**TERMINAL BUILDING: MEMORANDUM OF UNDERSTANDING AND ADMINISTRATIVE
MODIFICATION DATABASE**

Prepared by Jensen Hughes: April, 19, 2017

This document has been prepared by Jensen Hughes at the request of DEN. This document addresses all identified MOUs from 1990 through 2016 associated with the Terminal Complex at the Airport. It is intended to identify the scope of these MOUs and to identify whether they have been partially or completely superseded or if the MOU remains in effect. Note that superseded MOUs are often recommended to be retained for historic information.

LEVEL 5 SMOKE ZONES PROPOSED

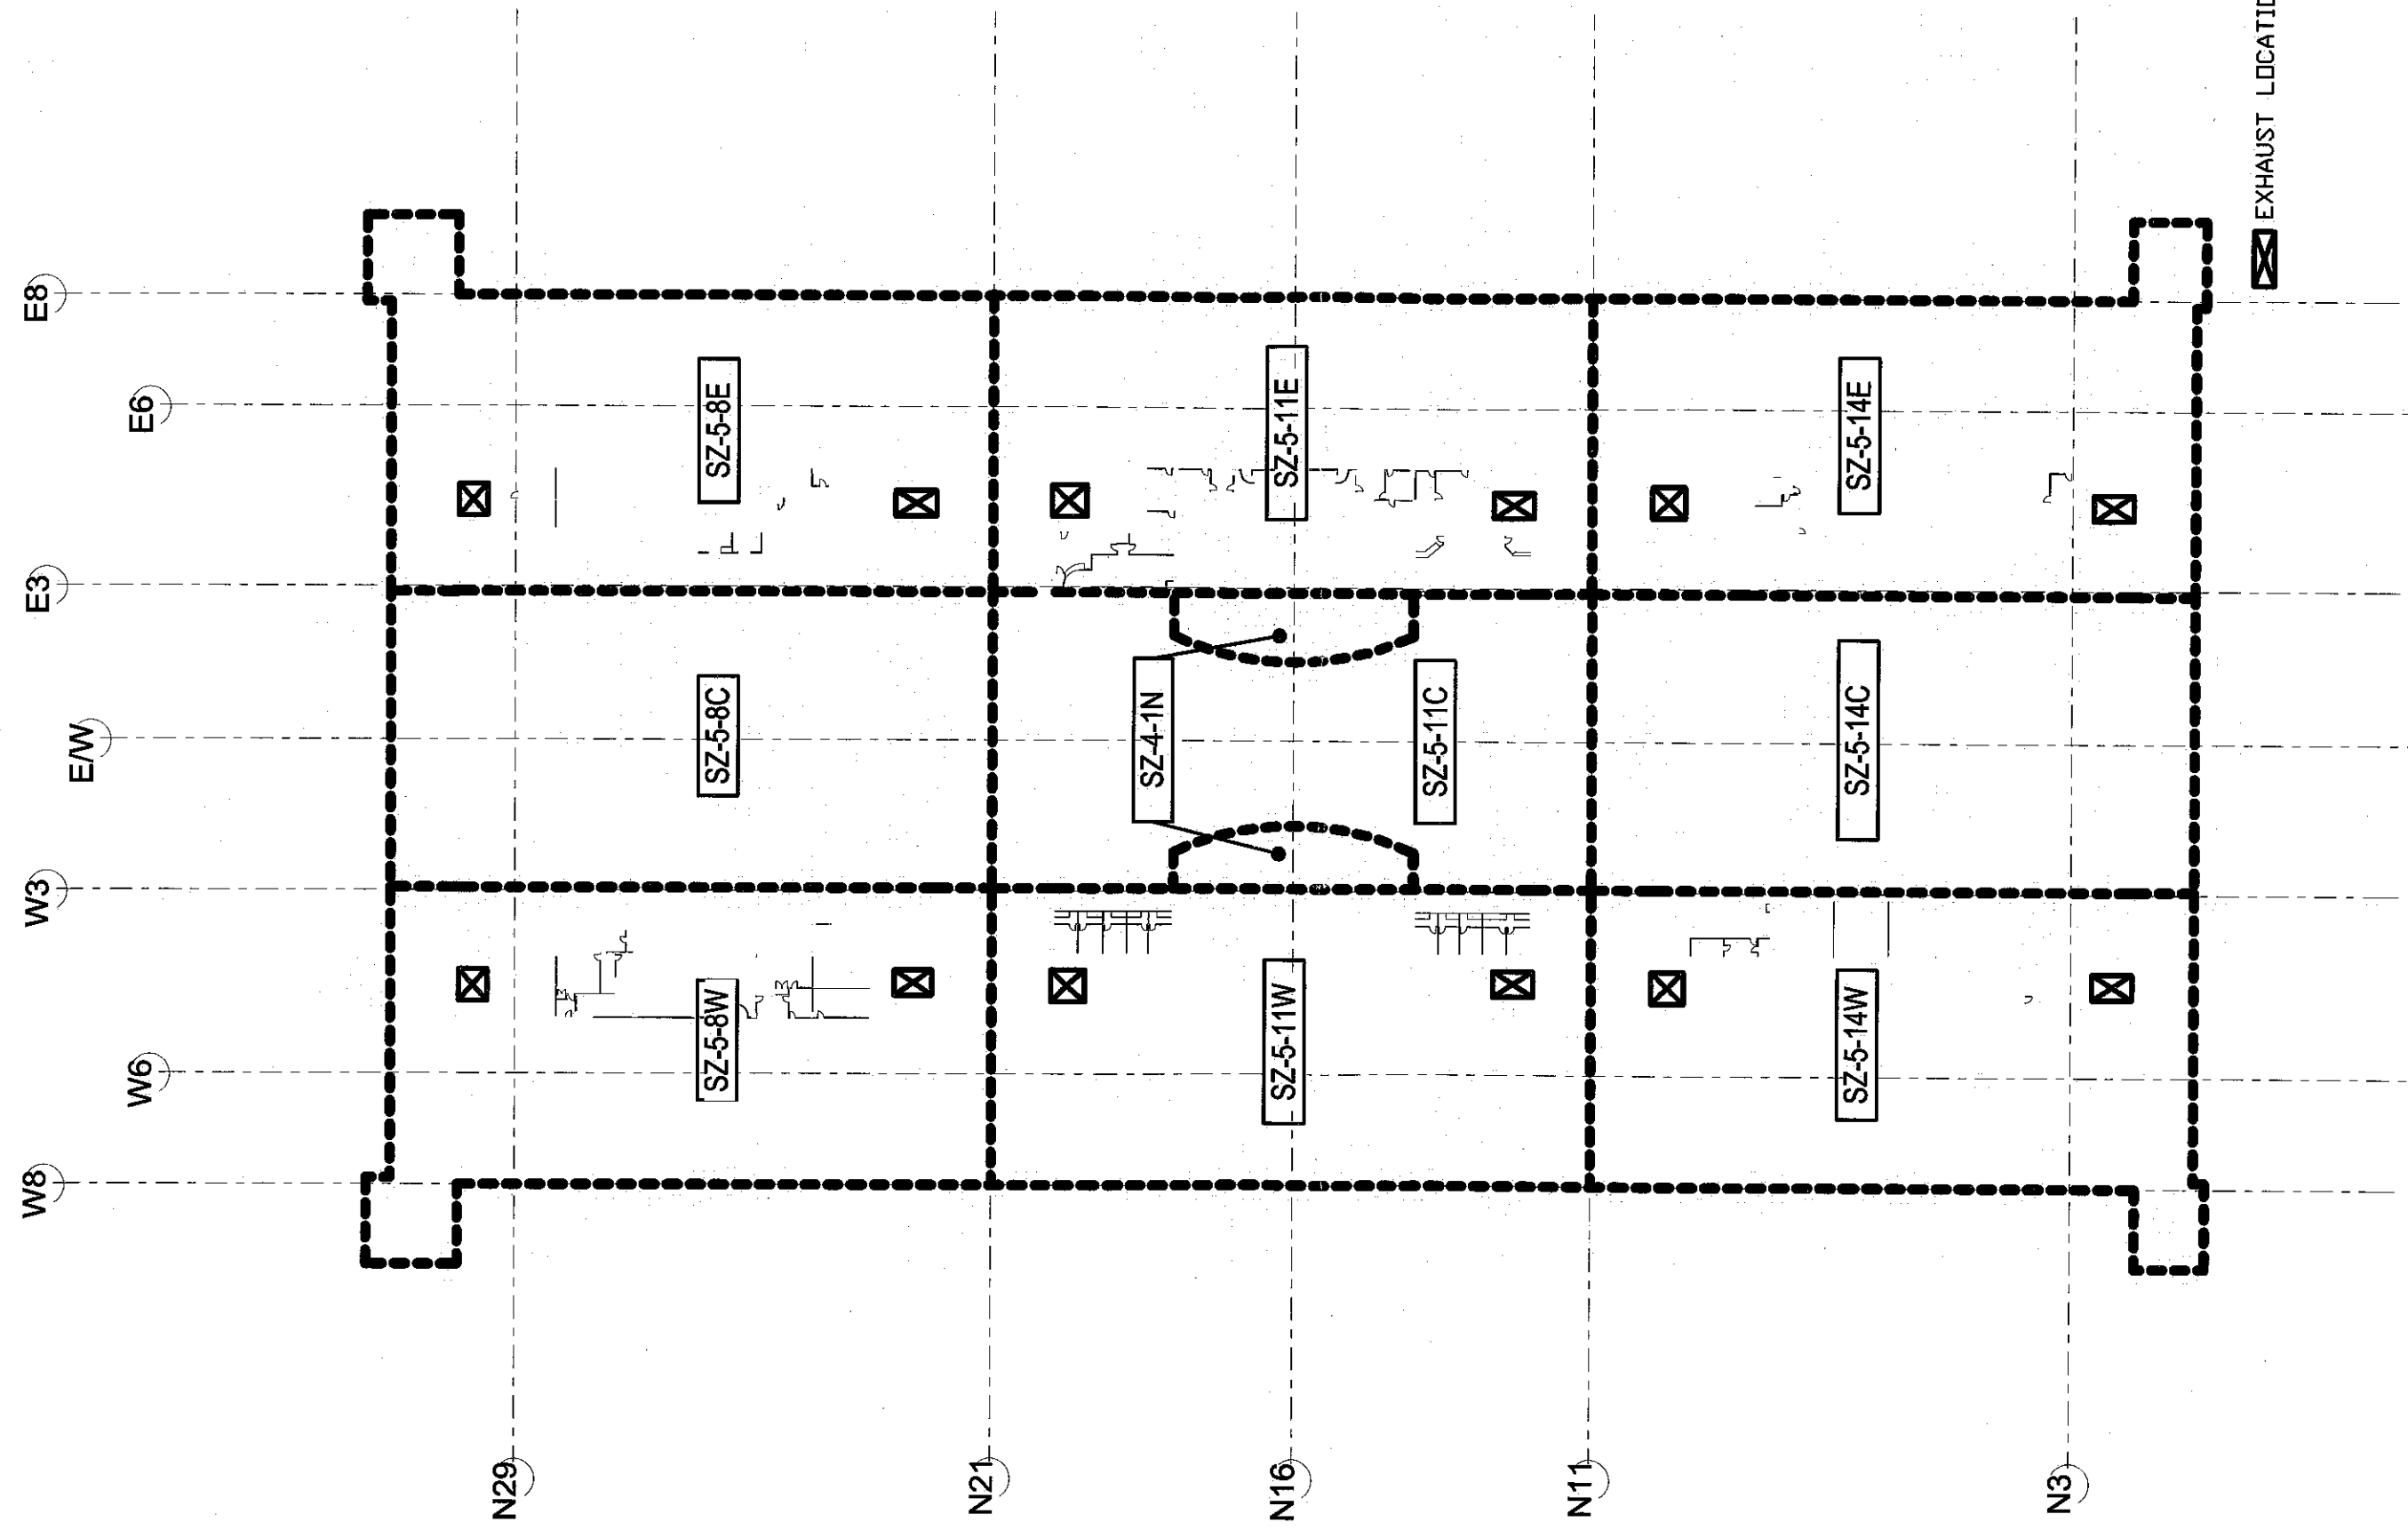
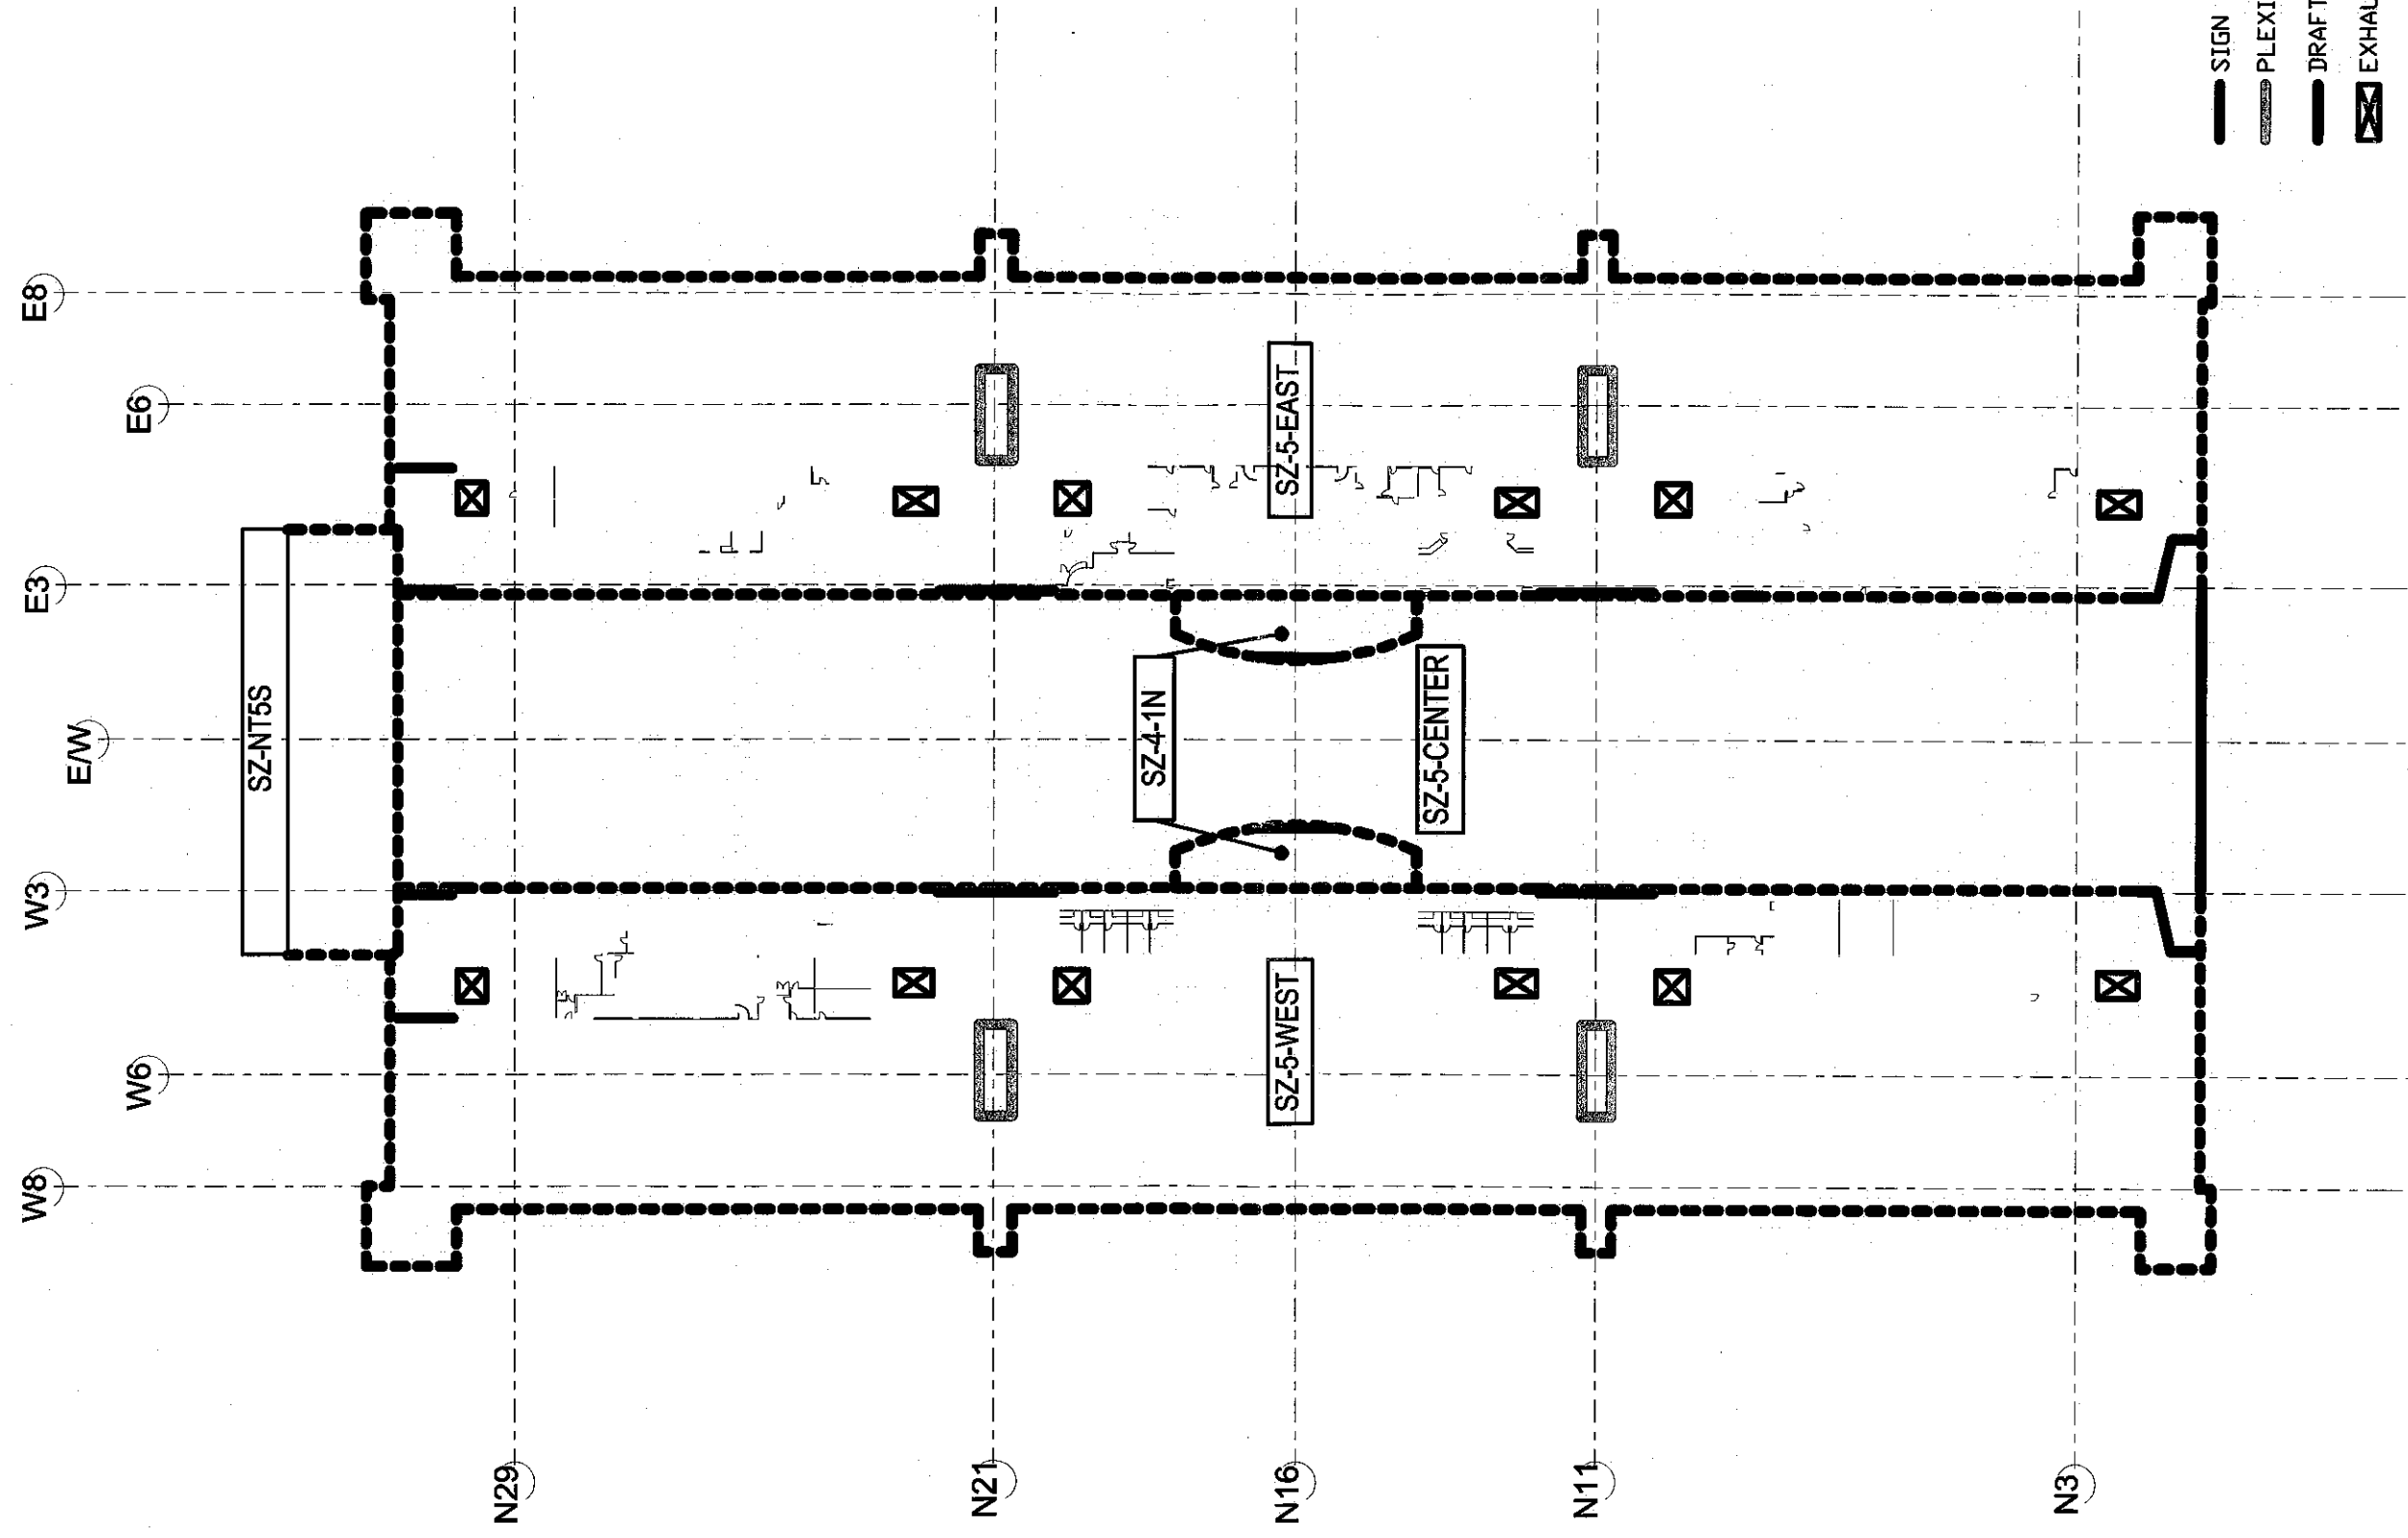
- SIGN DRAFT STOP
- ▭ PLEXIGLASS DRAFT STOP
- DRAFT STOP NEEDED
- ⊗ EXHAUST LOCATIONS
